Errata sheet affecting TLE986x and TLE987x BF step

N° 092/19

TLE986xQX Family - BF-Step

TLE987xQX Family - BF-Step

Figure 1 Example IRAM settings for the TLE9871QXA20

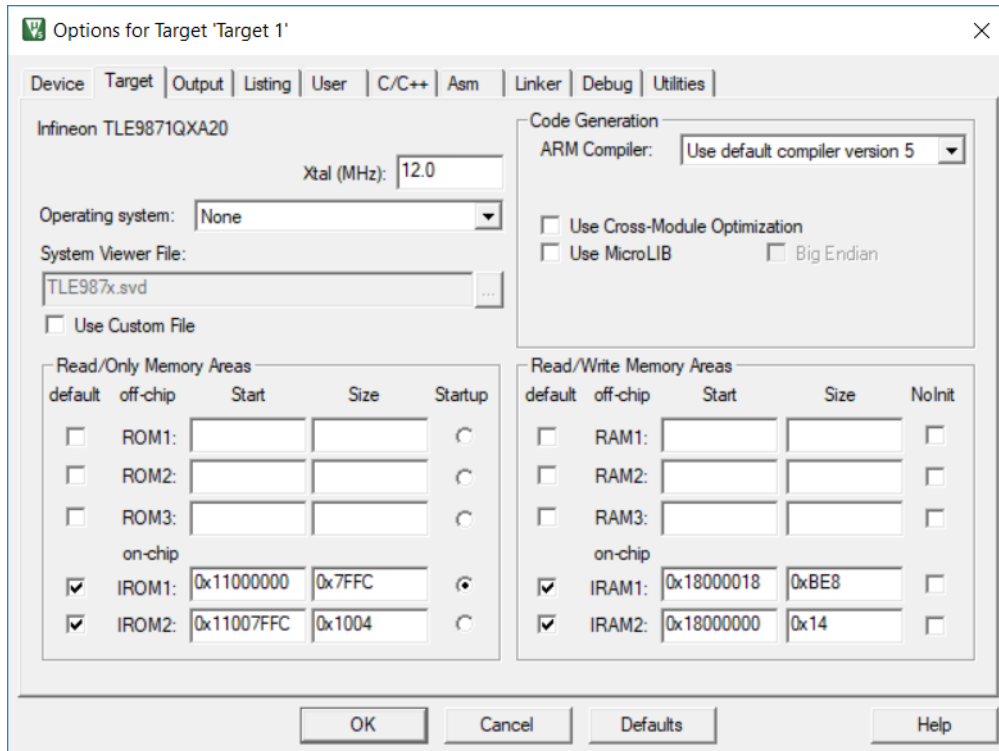
The function USER_NVM_ECC_CHECK uses for its operation 32 bytes on the user stack plus 1 byte in user RAM at address 0x18000015, this is not clearly specified in the BootROM User Manual.

Adjust the project IRAM settings to exclude this address from the RAM area usable by the linker. In order to maintain memory alignment a hole of four bytes, from 0x18000014 to 0x18000017 is recommended. **Figure 1** displays an example for the TLE9871QXA20. **Table 3** lists the recommended IRAM settings for each device.

Figure 4 Register view of specified SHPR2 register

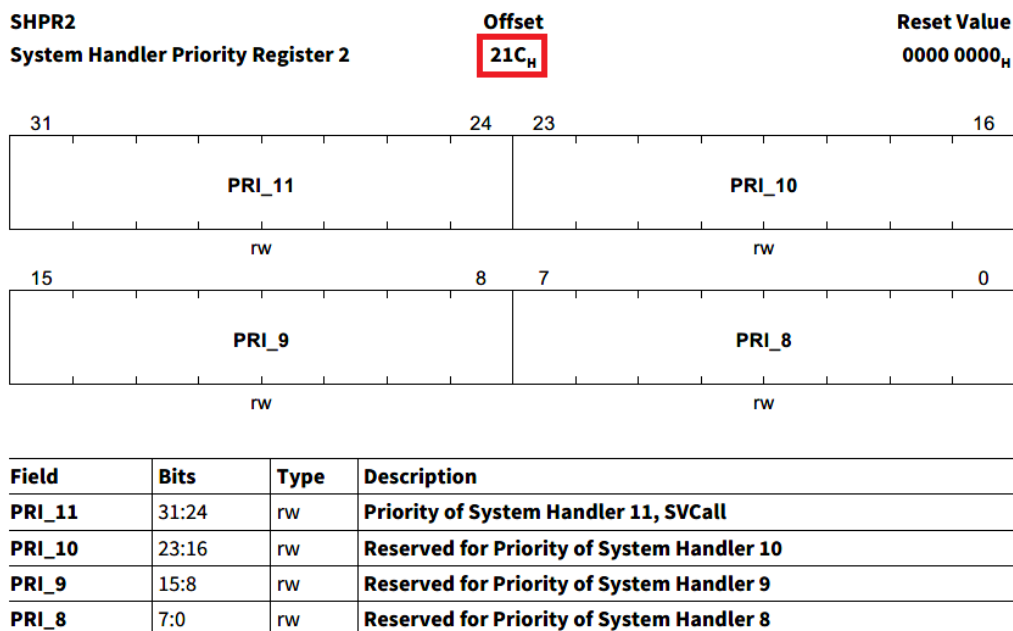
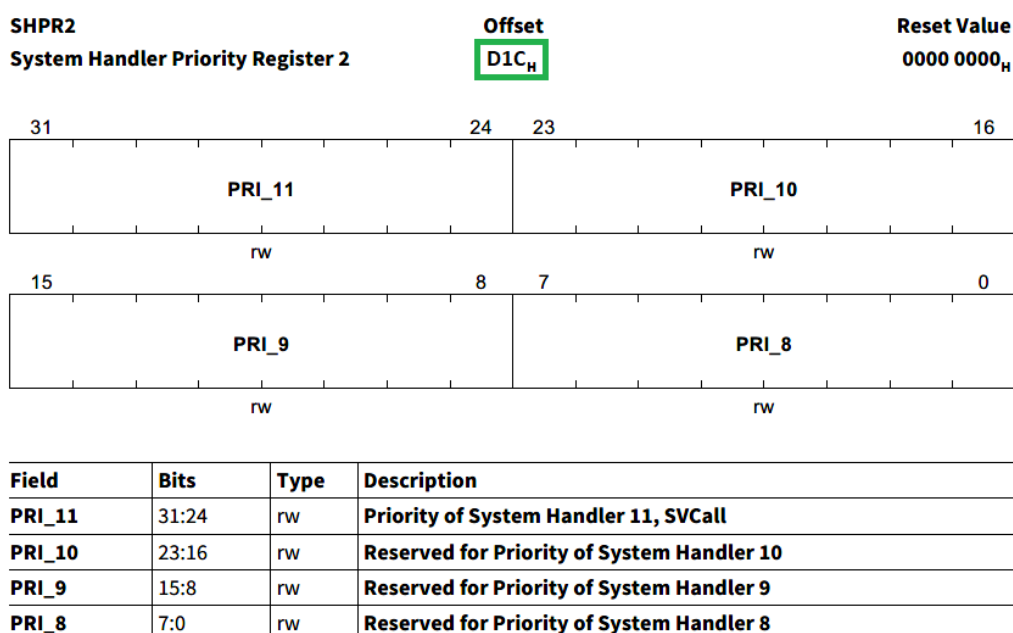
The address of the register SHPR2 is specified wrongly.

The implemented address for the register SHPR2 is 0xE000ED1C.

Fix with next user documentation update.
